VILLAGE OF GERMANTOWN
N112 W17001 MEQUON ROAD
GERMANTOWN, WI 53022

MEETING:	PLAN COMMISSION
DATE AND TIME:	MONDAY, APRIL 9, 2018 6:30 p.m.
LOCATION:	Germantown Village Hall Board Room

4/9/18 Plan Commission Meeting

**PLANNED DEVELOPMENT DISTRICT (PDD),
CERTIFIED SURVEY MAP(CSM) &
SITE PLAN REVIEW (REVISED)**
4/9/18 Plan Commission Meeting

REVISED SITE PLAN

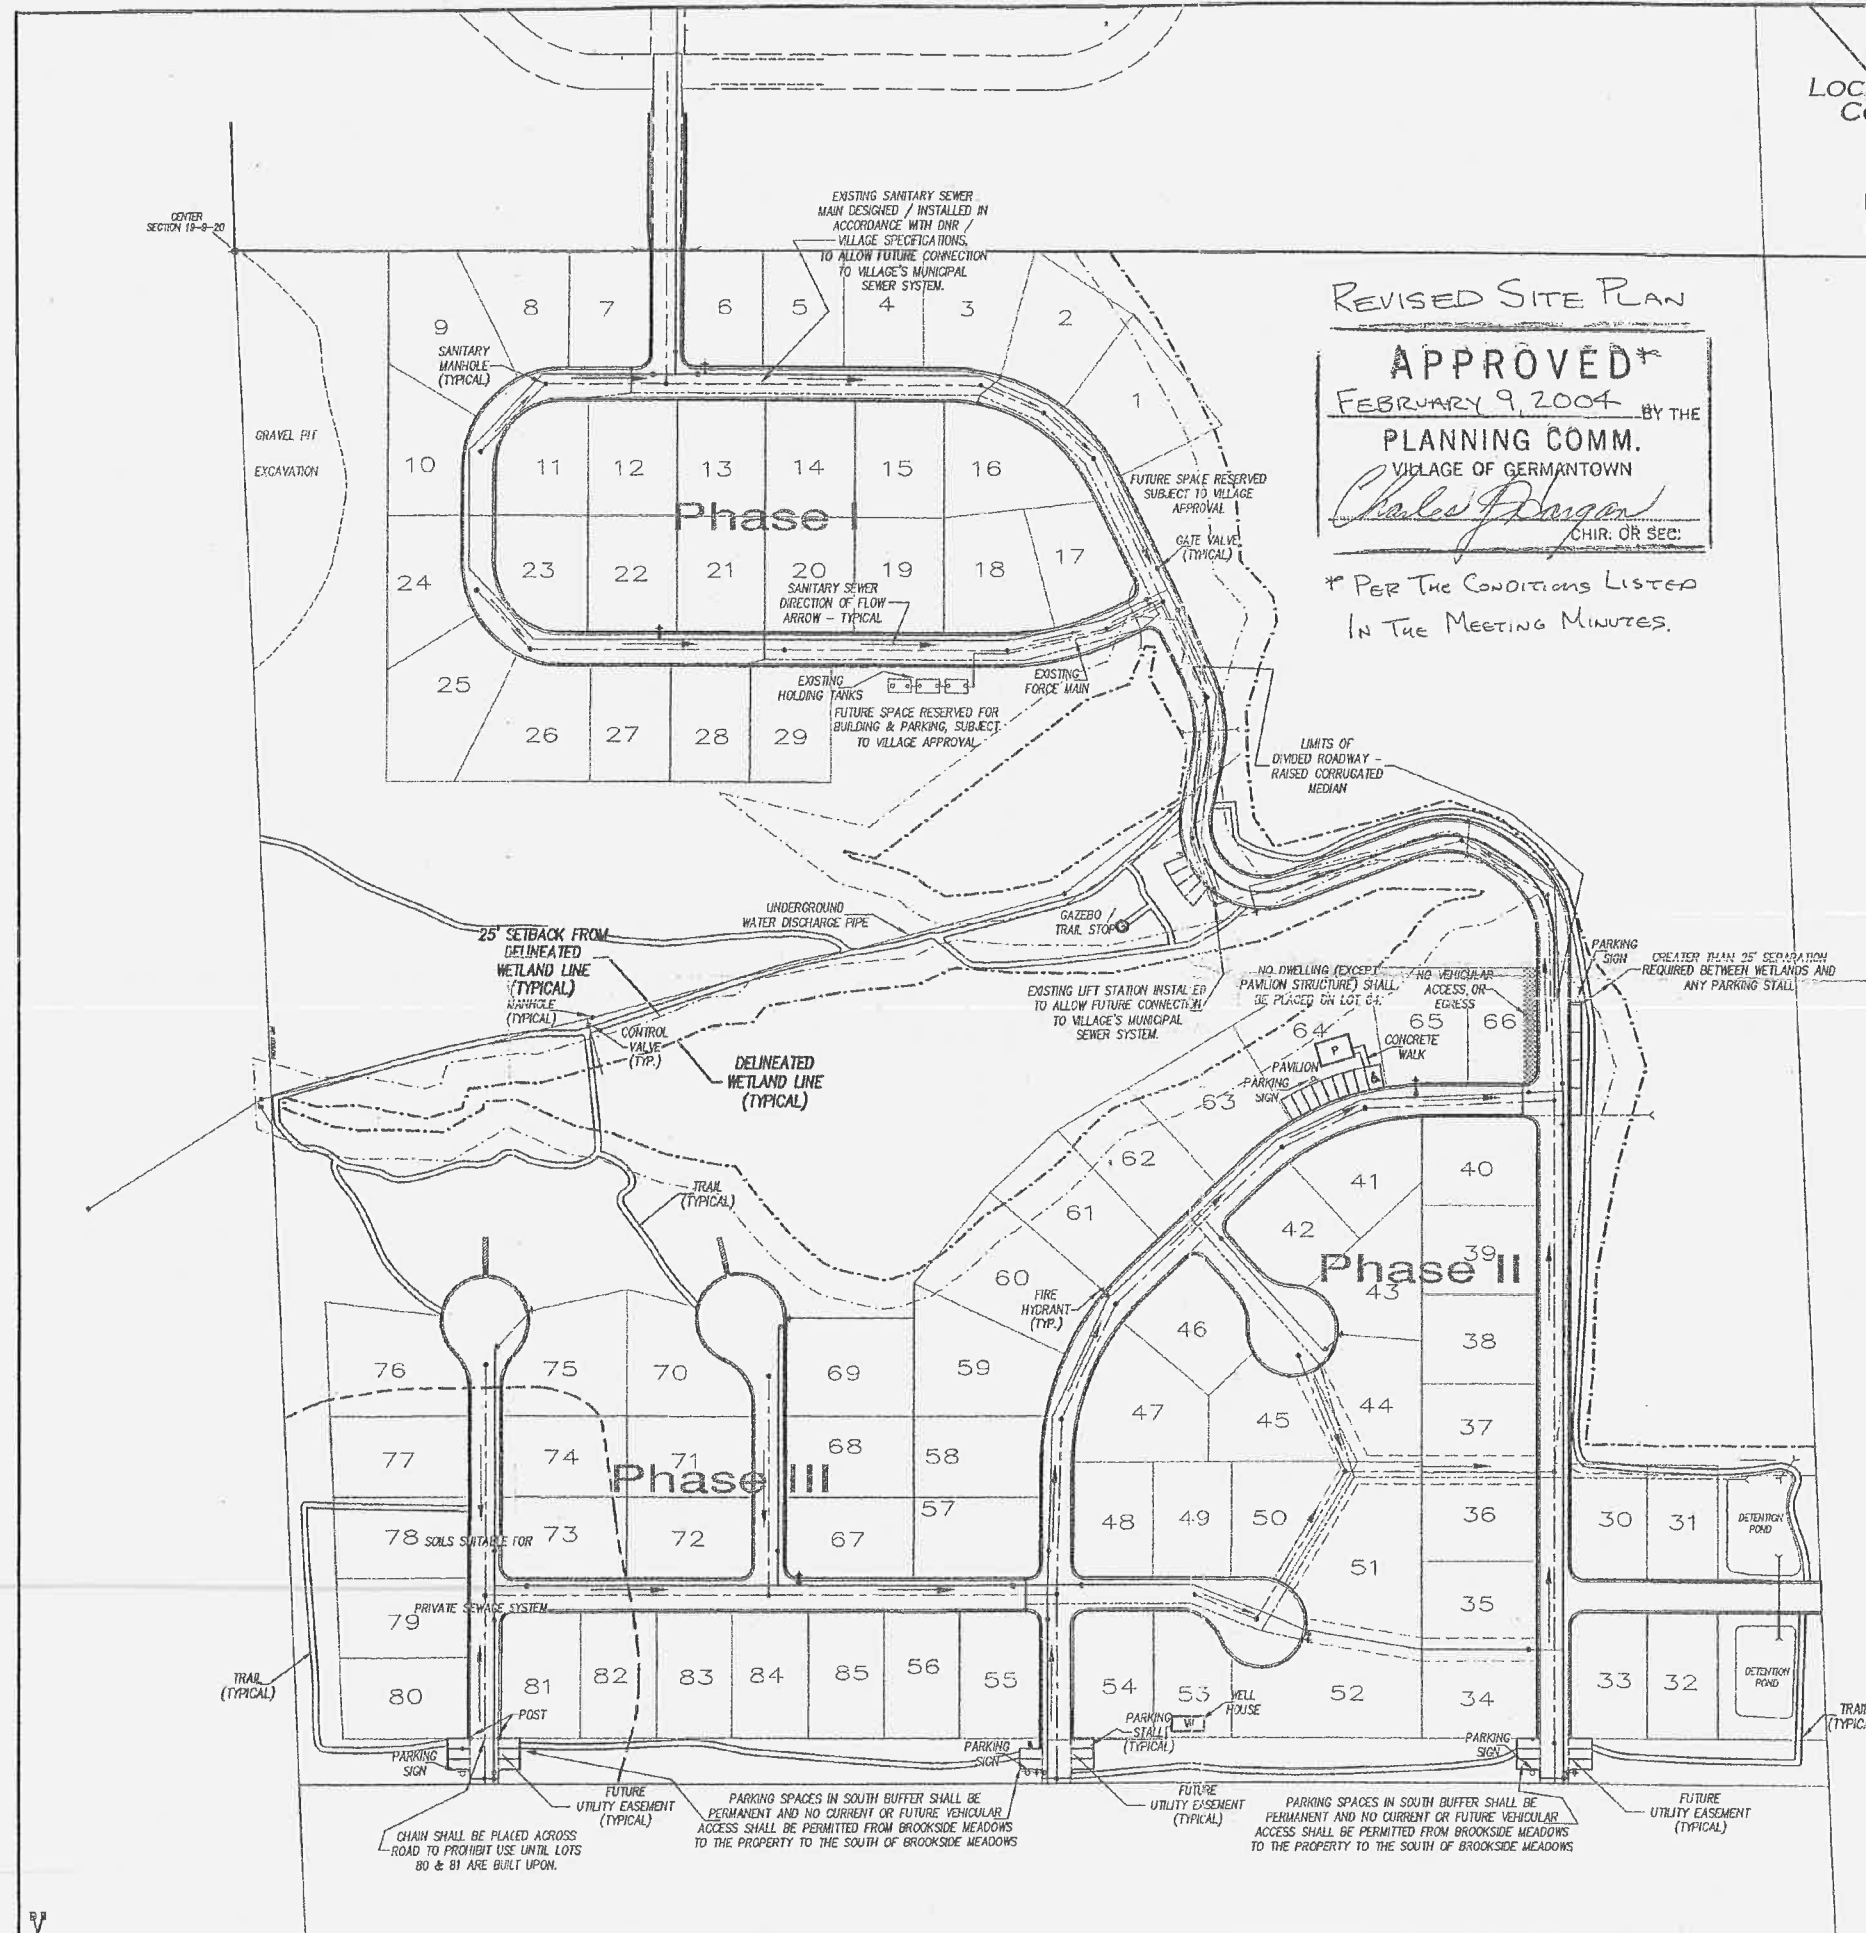
As shown on the original approved site plan (dated January 19, 2004), approximately ten of the original approved home sites contain either a portion of a delineated wetland or 25' wetland setback including Sites #1, #2, #30, #31, #59 through #65 (although #64 is required to not contain a home). Because the home sites in Brookside Meadows are not platted lots as is the case in a traditional subdivision plat, development is not subject to the Subdivision Code nor the requirement that all wetlands and wetland setback areas be located outside the boundaries of the home sites. Consequently, enforcement of the Shoreland-Wetland Code and 25' wetland setback in terms of prohibiting development activities within these areas has been more difficult than if the wetland boundary and/or setback areas did not encroach into the home sites.

Similarly, the entire trail system, gazebo, pavilion and "guest" parking stalls strategically located throughout the site also need to be shown on the revised site plan as presented in the current approved site plan.

1. The trail system, gazebo, pavilion and “guest” parking stalls shown in the approved site plan dated January 1, 2004 shall be presented on the revised site plan as originally approved.

SITE GRADING AND
UTILITY PLAN
1" = 20'

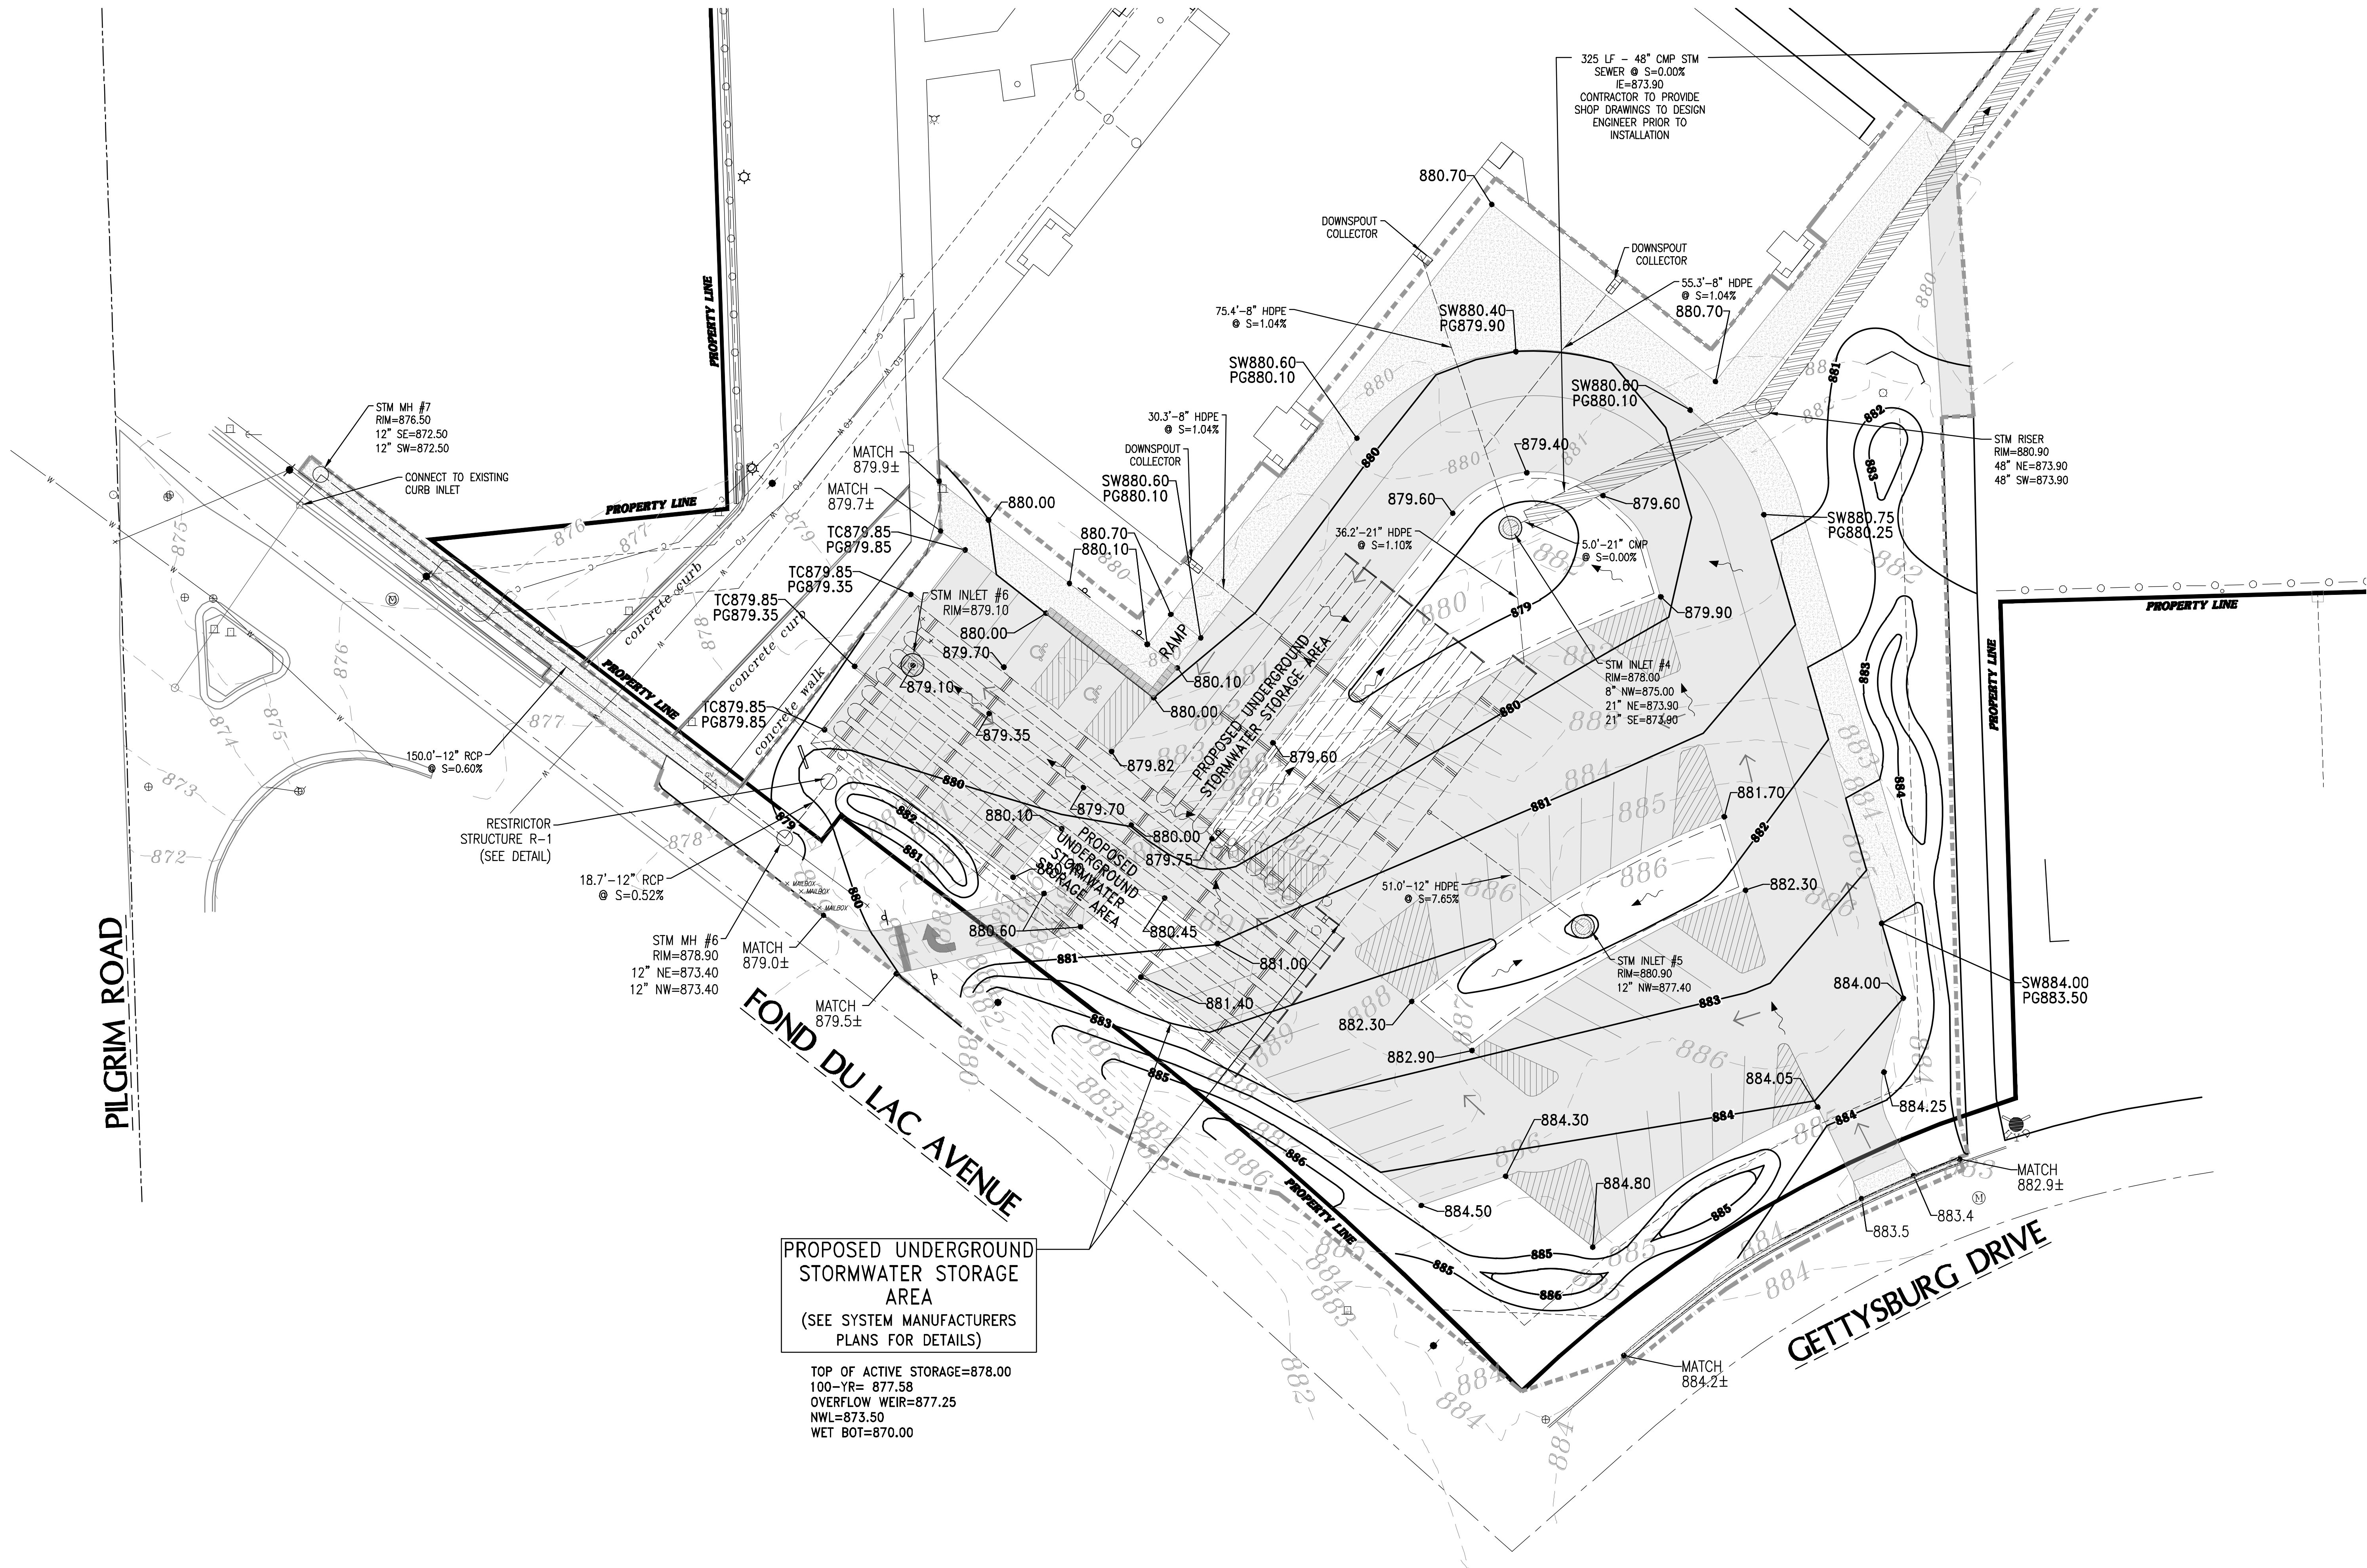
C400 Site Grading and Utility Plan

1. *Is there a step at the door on the northeast end of the building? If so note the step on the plans. Note a landing is required at the door.*
2. *The sanitary sewer connection to the existing 10" in Roberts Drive shall be made with a manhole. Manhole shall match Village standard detail (attached)*
3. *Adjust cleanout spacing to meet state plumbing code. (Max of 300' upstream of the manhole)*

4. Add spot elevations and additional contours to clearly define the overflow. Contours shown do not match the note. Note indicates top @ 875.5 but the 875 contour does not continue around the north side of Rain Garden.
5. Please show existing watermain on site and ensure all required water separation (both vertical and horizontal) are provided.
6. It appears some contours are missing or the rim elevations is incorrect near STM inlet #1. Rim elevation is shown as 867.50 but adjacent spot grades are 878.8.
